NRC RAI Letter No. PTN-RAI-LTR-041

SRP Section: 02.05.01 - Basic Geologic and Seismic Information

NRC RAI Number: 02.05.01-33 (eRAI 6024)

Proposed Turkey Point Units 6 and 7
Docket Nos. 52-040 and 52-041
FPL Draft Revised Response to NRC RAI No. 02.05.01-33 (eRAI 6024)
Page 6 of 6

Figure 1. Tectonic map of Cuba, showing faults in Cuba described in FSAR Subsection 2.5.1.1.1.3.2.4.

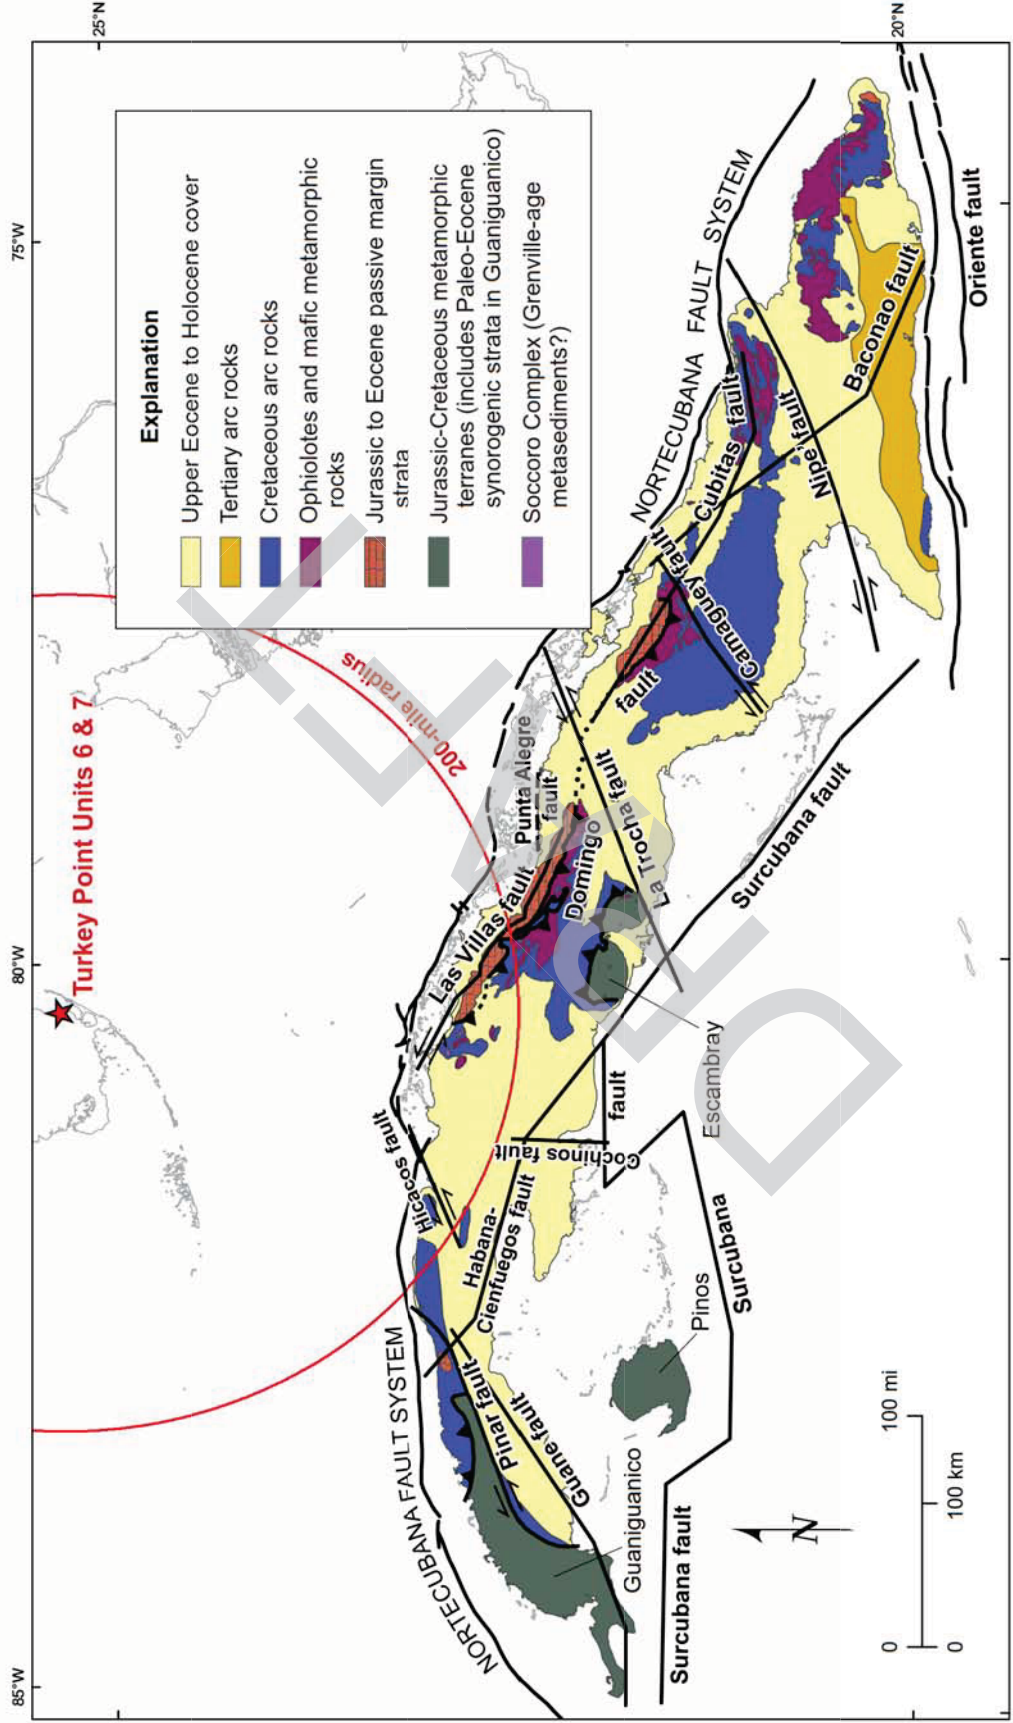
FSAR Section 2.5.1.1.1.3.2.4, "Structures of Cuba", cites FSAR Figures 2.5.1-247, 2.5.1-251 and 2.5.1-268, which illustrate Cuban tectonic features at present, however, many faults appear to be omitted entirely from figures including the Habana-Cienfuegos fault, Cubitas fault, Guane fault, Nipe fault, and Baconao fault.

In order for the staff to assess the tectonic and structural features within the site region and in accordance with 10 CFR 100.23, please provide a single figure, or composite figures that clearly depict all tectonic features discussed in FSAR Section 2.5.1.1.1.3.2.4.

Figure 1 is a compilation map showing the faults in Cuba described in FSAR Subsection 2.5.1.1.1.3.2.4, including the Nortecubana fault system, Surcubana fault, Pinar fault, Guane fault, Habana-Cienfuegos fault, Hicacos fault, Cochinos fault, Las Villas fault, Domingo fault, La Trocha fault, Camaguey fault, Cubitas fault, Nipe fault, Baconao fault, Oriente fault, and Punta Alegre fault. Multiple sources were used to compile the faults shown on this map, including: Kerr et al. (1999), Tait et al. (2009), Pardo et al. (2009), Hall (2004), French and Schenk (1997), and Cotilla-Rodriguez et al. (2007) (FSAR References 2.5.1-443, -448, -439, -770, -492, and -494).

Figure 1 does not show the locations of Malloy and Hurley's (Reference 1) postulated Sierra de Jatibonica and offshore Las Villas faults, both of which are located in the Straits of Florida north of Cuba. Those structures are described and shown on maps that accompany revised responses to RAIs 02.05.01-27, 02.05.01-16, and 02.05.03-02.

Figure 1. The two zones of secondary porosity on B-604 (DH) showing the lithology, caliper, natural gamma, velocity (Vs and Vp) and acoustic televiewer logs (1 of 3)

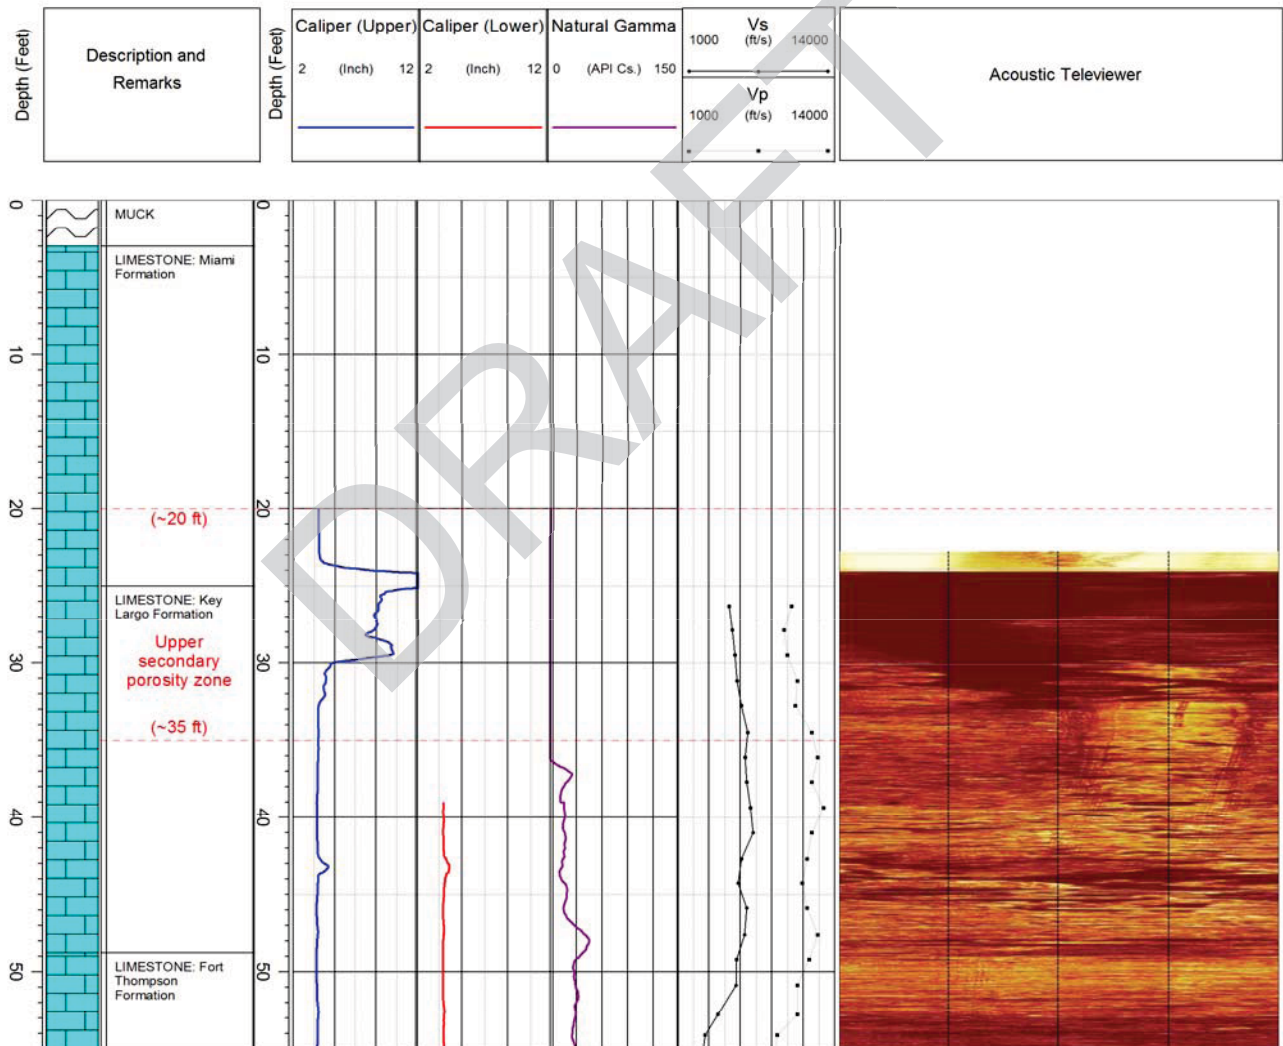
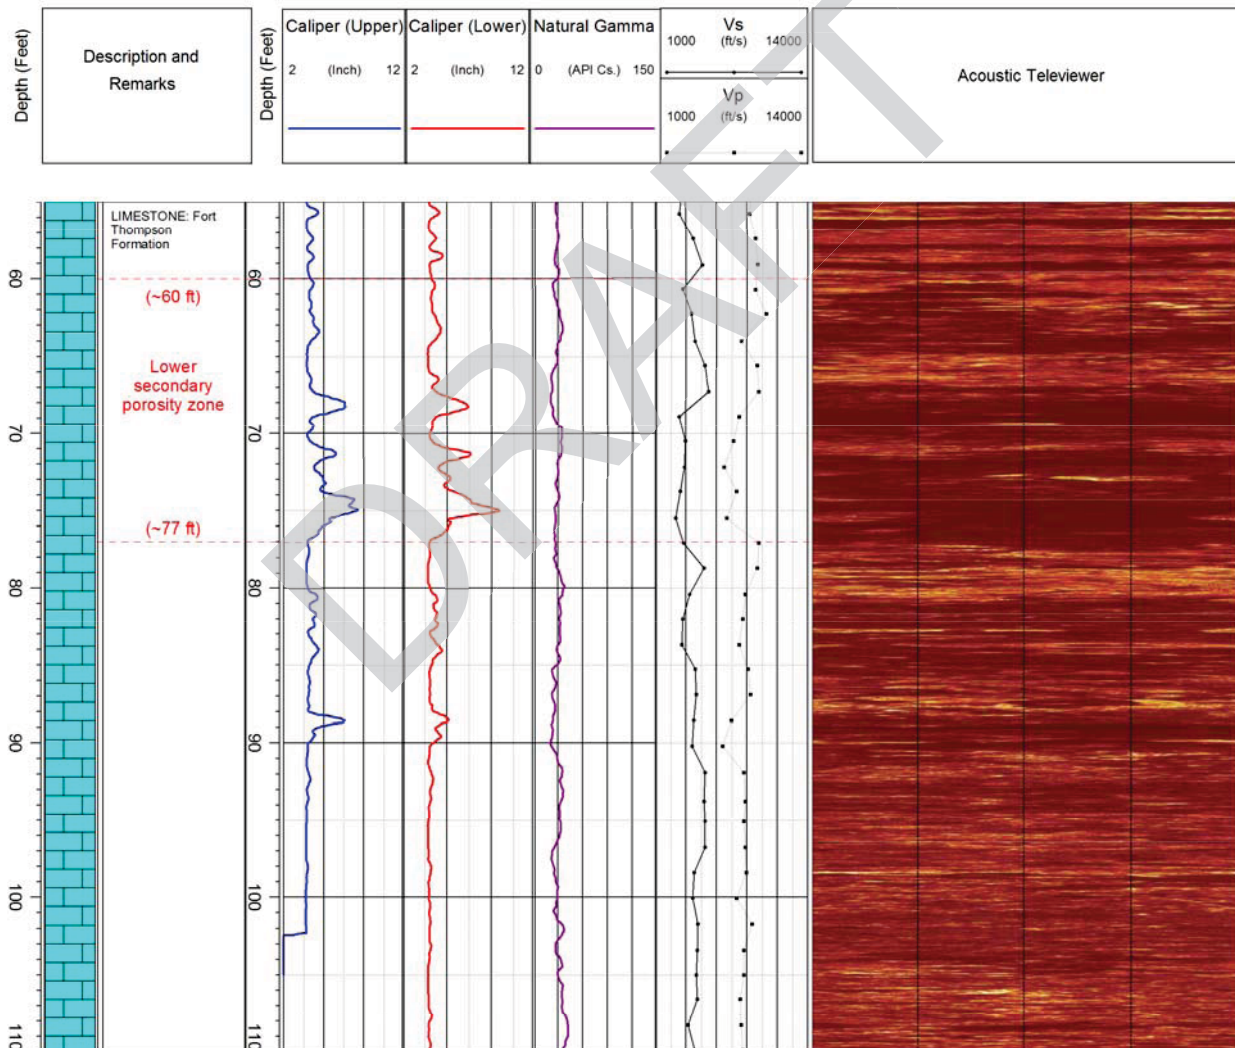
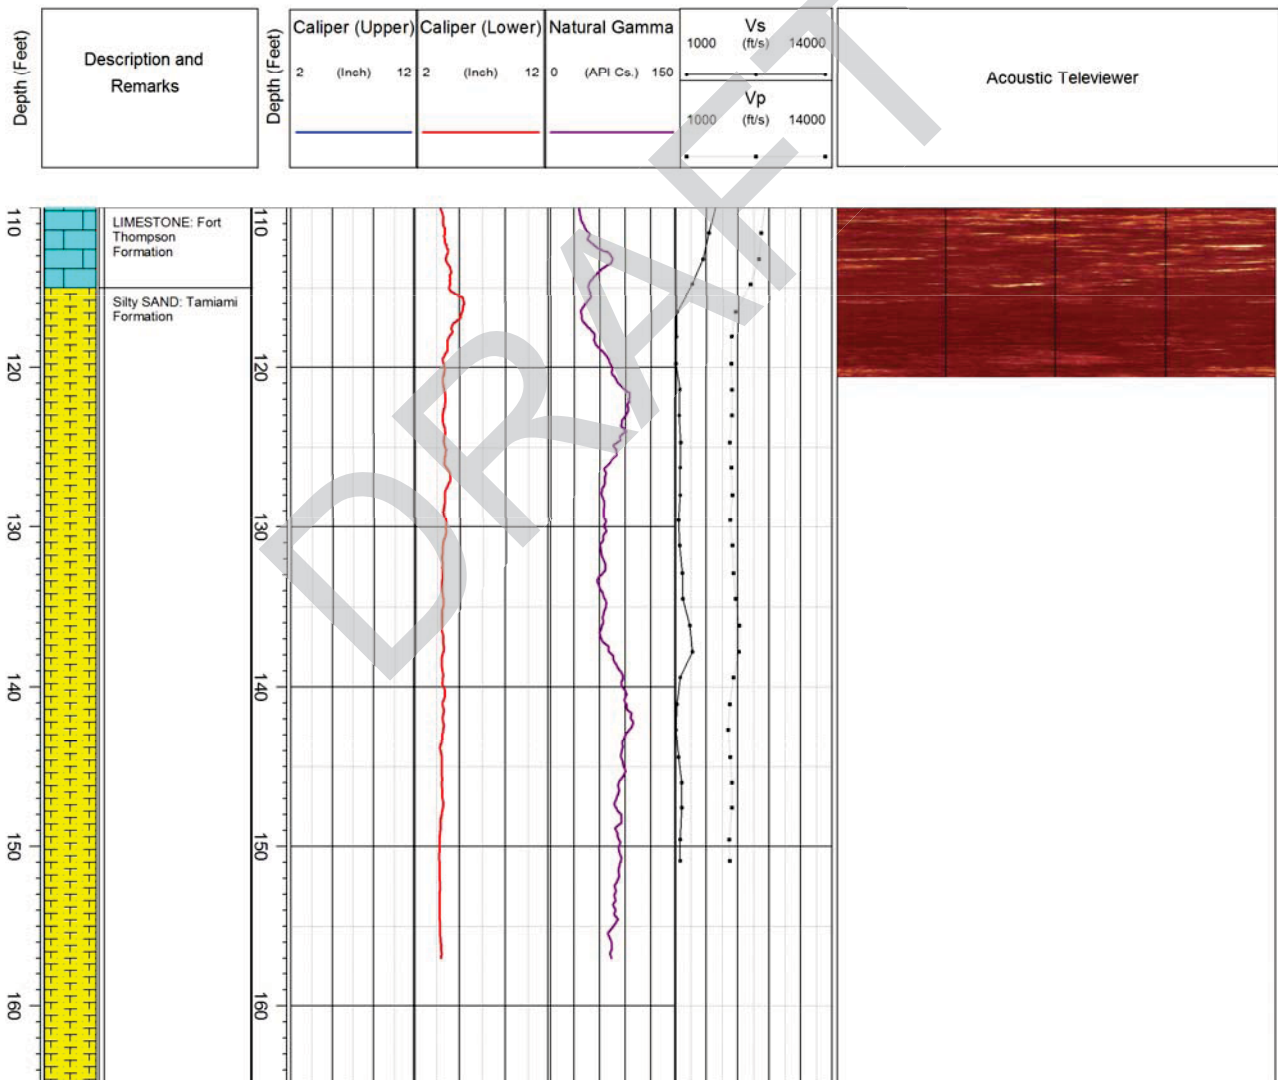
FSAR Section 2.5.1.2.4 discusses limestone dissolution features and states that zones of preferential secondary porosity exist within (1) an upper zone within Key Largo Limestone and (2) a lower zone within Fort Thompson Formation, and that these zones include cavities verified from televiwer and caliper logs. Staff notes that the Key Largo LS will be the bearing layer for SSC buildings. In order for the staff to evaluate the dissolution potential at the TPNPP site and in support of 10 CFR 100.23, please address the following:

- a) Discuss the possible origins of these subsurface voids and evaluate if this is still consistent with your statement “there is no evidence for sinkhole hazards or for the potential of surface collapse due to the presence of large underground openings” on page 2.5.1-229.
- b) Discuss the possibility that these zones of secondary porosity are in the same stratigraphic unit that expresses the karst/sinkhole-like features seen immediately off shore to the east of the TPNPP site.

As described in FSAR Subsection 2.5.1.2.4, the two zones of secondary porosity were identified at the site following review of the geophysical logs, the geotechnical boring logs, and the shear wave velocity logs. In general, the zones of secondary porosity were identified based on increases in borehole diameter on the caliper logs, darkened areas on the acoustic televiwer images, typically lower P-S wave velocity values, and loss of drilling fluid and rod drops. Figures 1 through 3 show the approximate locations of the two zones of secondary porosity on three example-boring logs, B-604 (DH), B-608 (DH), and B-710 G (DH) and their locations at the Turkey Point Units 6 & 7 site are seen on FSAR Figure 2.5.1-228 and FSAR

Figure 2.5.4-202. Figures 1 through 3 were compiled using the lithology, caliper, natural gamma, acoustic televiwer, and velocity (Vs and Vp) logs.
